# SEATTLE ARENA

1700 FIRST AVENUE SOUTH

DOWNTOWN DESIGN REVIEW BOARD | RECOMMENDATION #3 | 2015 SEPT 1ST

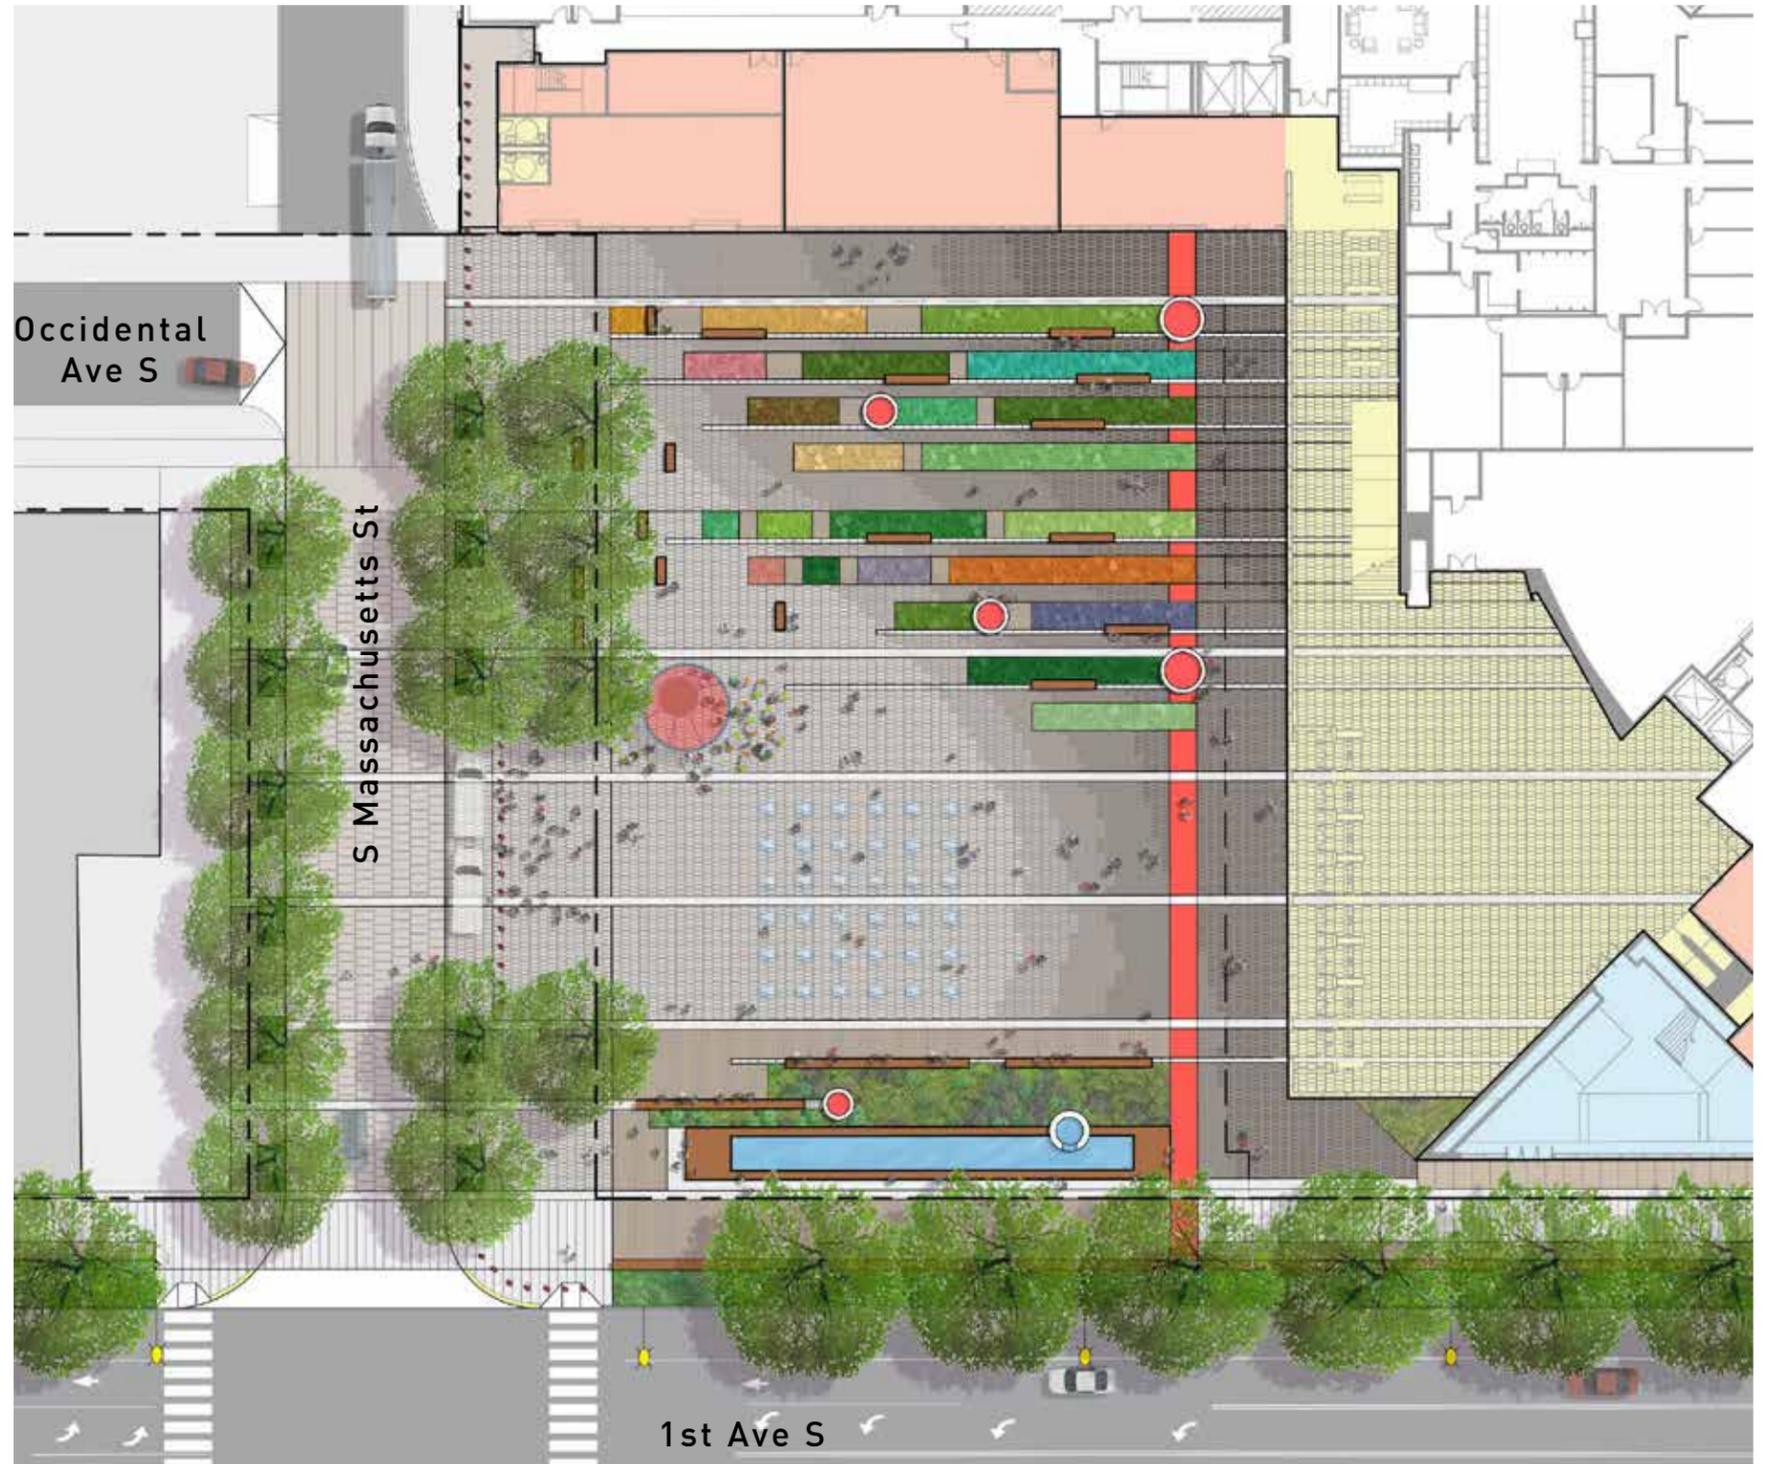
3. The Board supported the inside/outside paving materials and patterns, and encouraged further evolution of such integrated plaza and building design. (D-3)

Comment noted. The design team has taken this comment into consideration and has incorporated paving inside and outside during the evolution of the plaza.

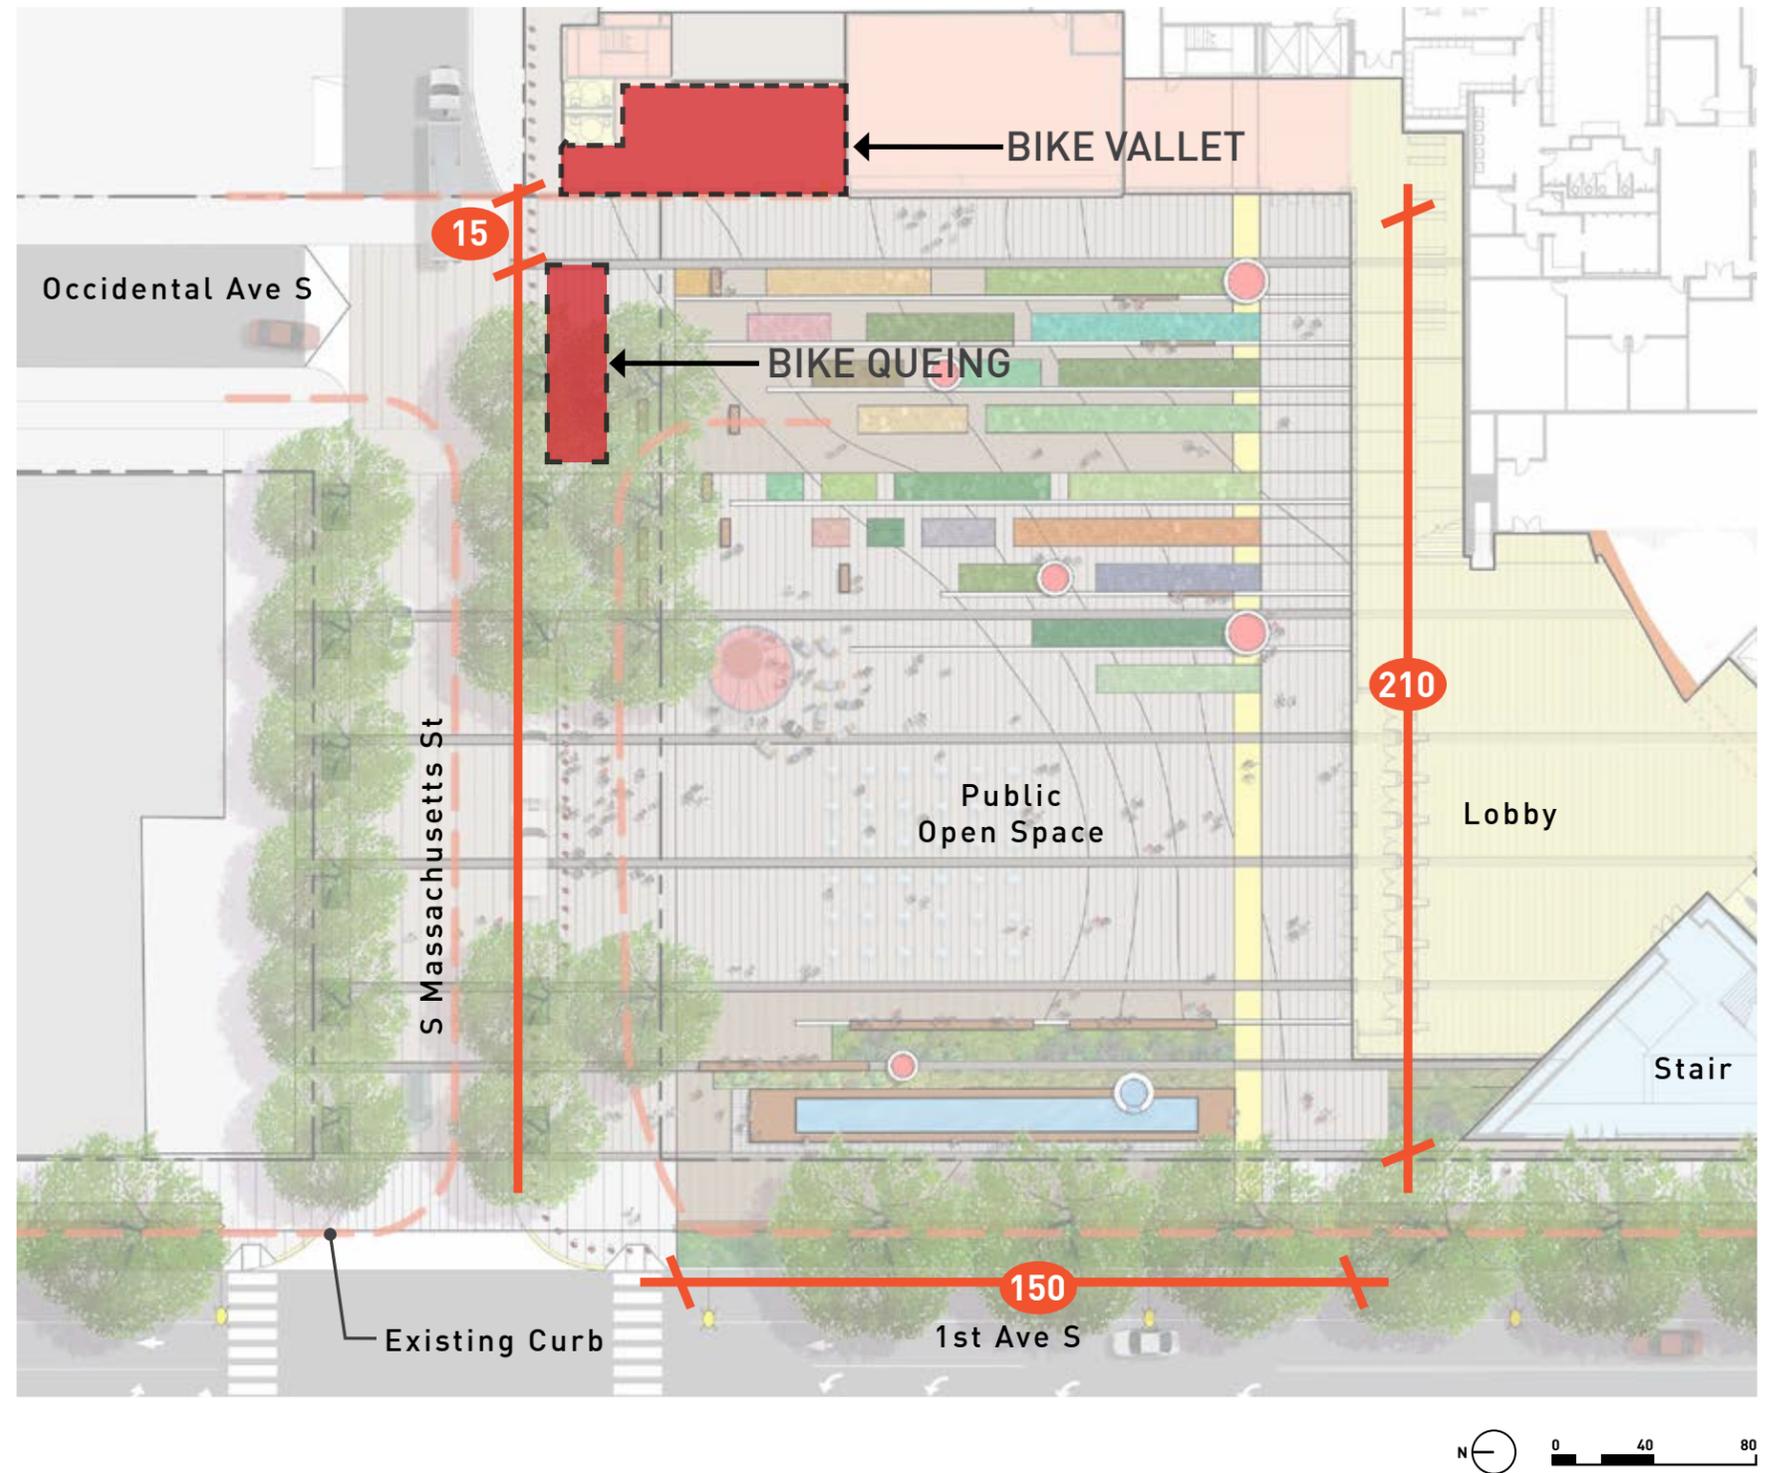
4. The Board requested a plan of the north edge of the plaza, the relocated Massachusetts street/curbline, and the adjacent Mariners plaza along Occidental. The plan should show dimensions and pedestrian flows through the 'pinch point' near the bike valet, including bike patron queuing.(D-6, E-1)

Comment noted. (see graphic this page)

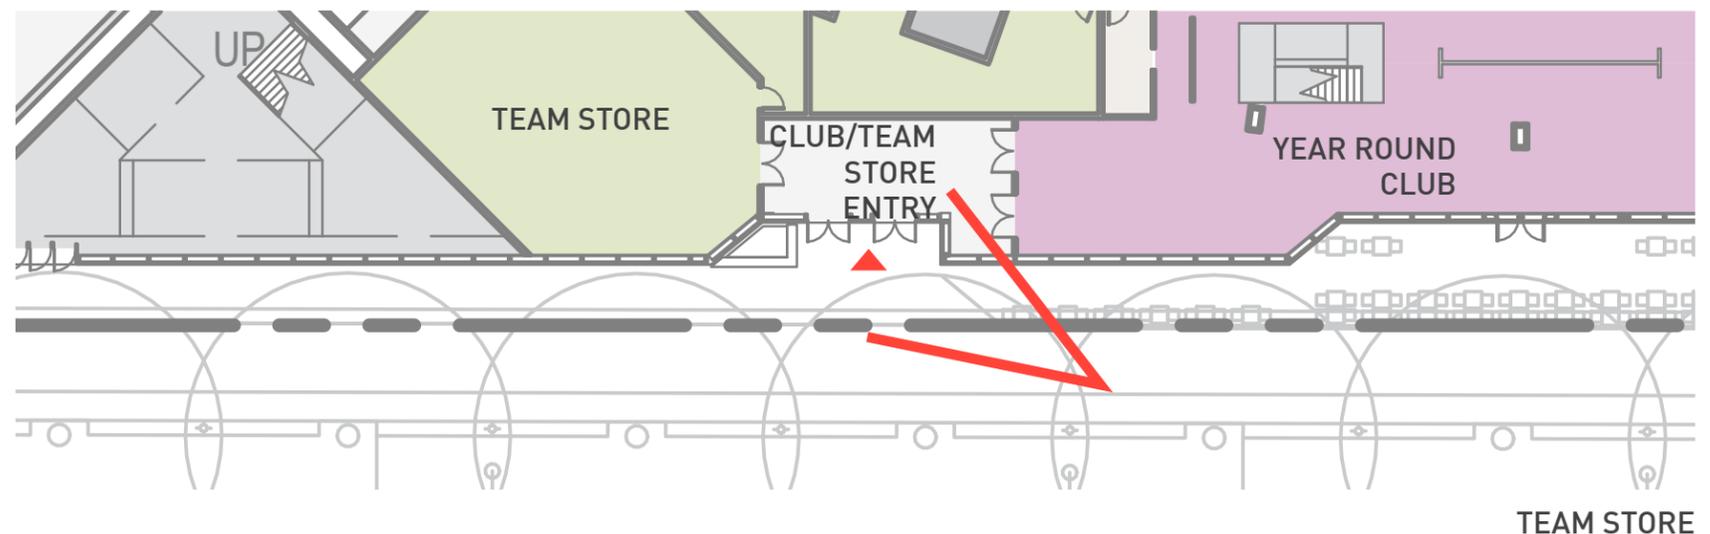
5. The Board agreed the balance of active/inactive ground level building uses was acceptable but requested more details on various specifics: the location and number of public entry doors into the restaurant/club; detailed views of each planter, canopy and/or doors at the indents along First Avenue; glass or spandrel treatments at 'performer/water service' (pg 77); doors and glass treatment at the triangular exit stairs. (C-1, C-3)

Views along 1st avenue at the club, team store, triangular stair and performer marquee have been provided. There is a consistent glass treatments across all of 1st avenue. Entry doors at the club have been indicated.

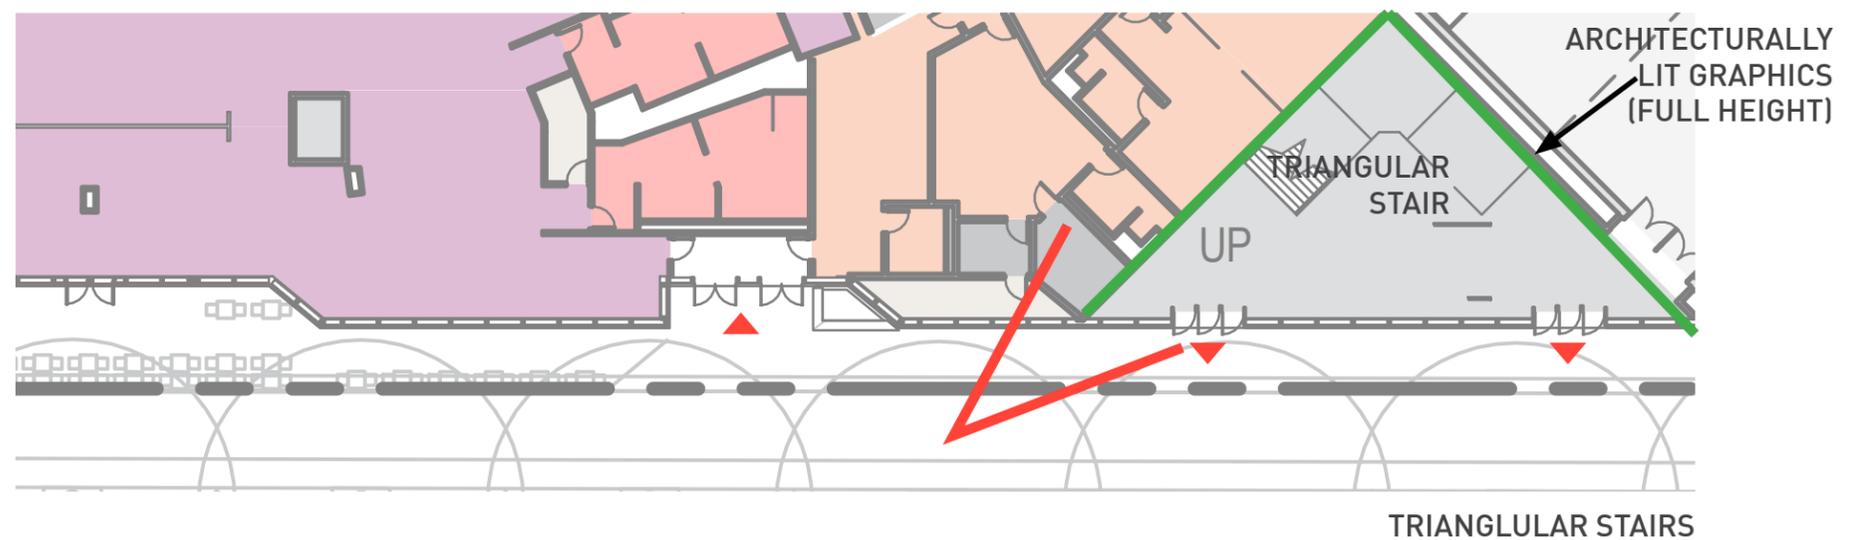
5. The Board agreed the balance of active/inactive ground level building uses was acceptable but requested more details on various specifics: the location and number of public entry doors into the restaurant/club; detailed views of each planter, canopy and/or doors at the indents along First Avenue; glass or spandrel treatments at 'performer/water service' (pg 77); doors and glass treatment at the triangular exit stairs. (C-1, C-3)

Comment noted. (see graphic this page)

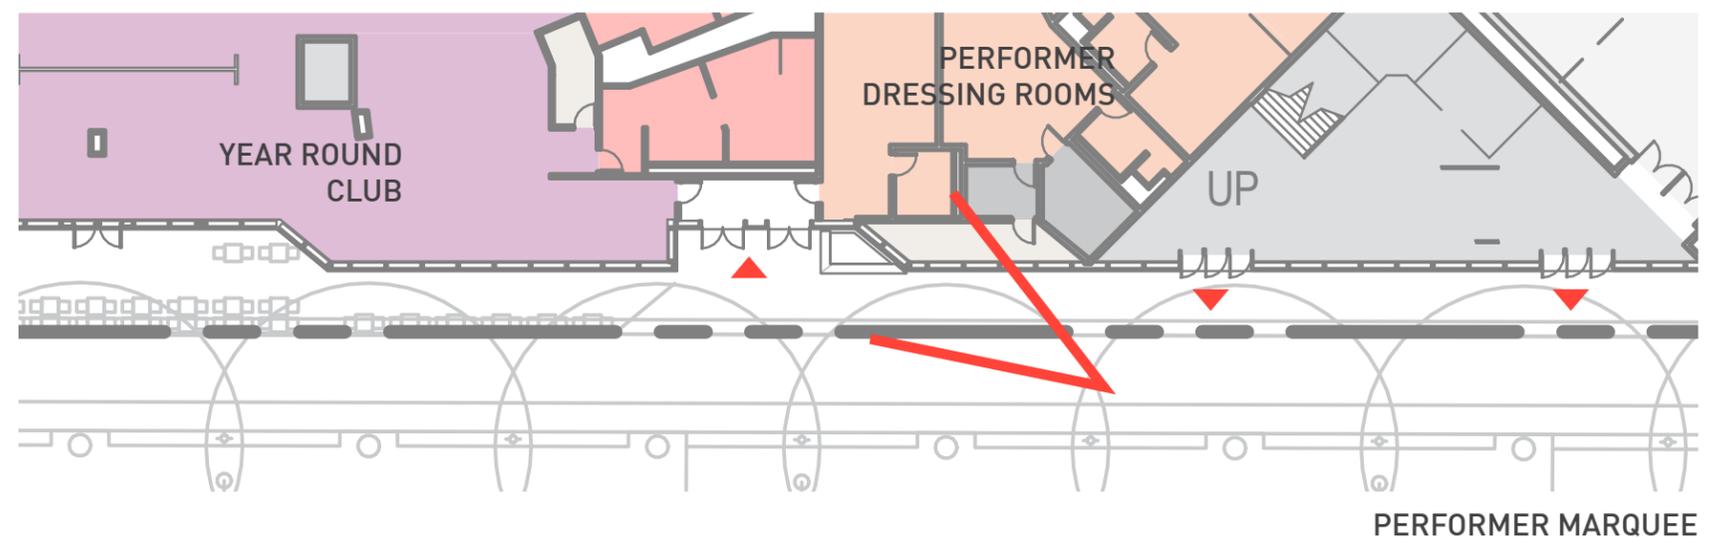
5. The Board agreed the balance of active/inactive ground level building uses was acceptable but requested more details on various specifics: the location and number of public entry doors into the restaurant/club; detailed views of each planter, canopy and/or doors at the indents along First Avenue; glass or spandrel treatments at 'performer/water service' (pg 77); doors and glass treatment at the triangular exit stairs. (C-1, C-3)

Comment noted. (see graphic this page)

CLUB

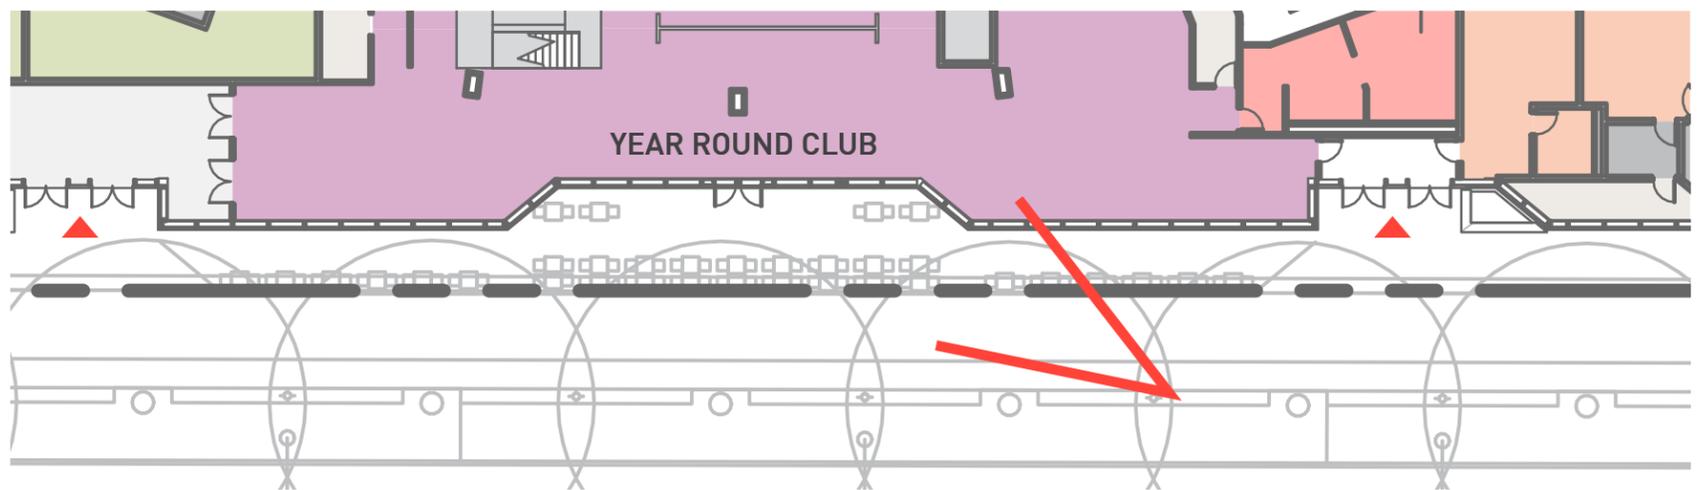
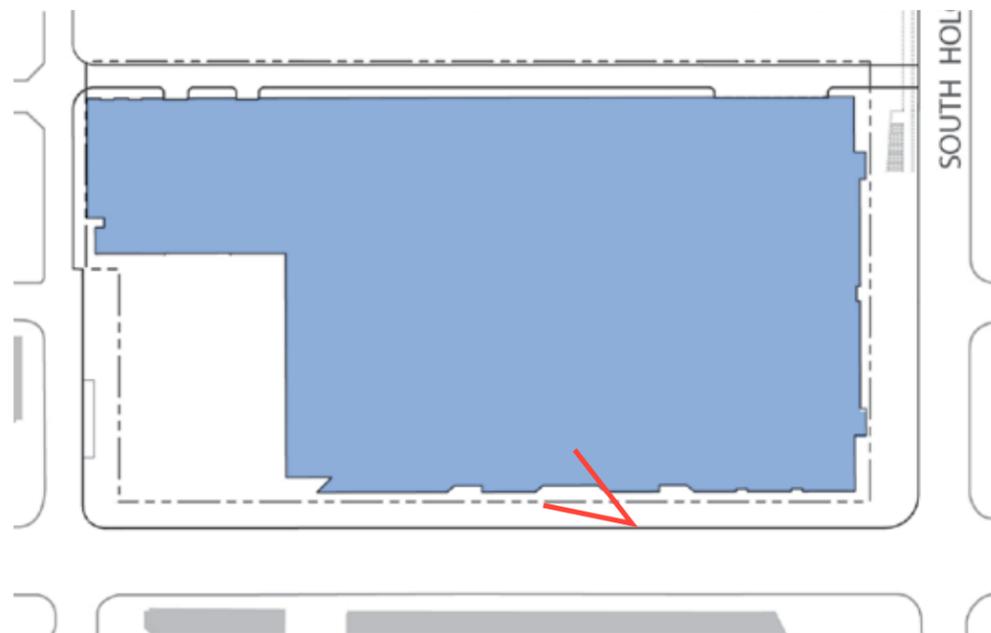
5. The Board agreed the balance of active/inactive ground level building uses was acceptable but requested more details on various specifics: the location and number of public entry doors into the restaurant/club; detailed views of each planter, canopy and/or doors at the indents along First Avenue; glass or spandrel treatments at 'performer/water service' (pg 77); doors and glass treatment at the triangular exit stairs. (C-1, C-3)

Comment noted. (see graphic this page)
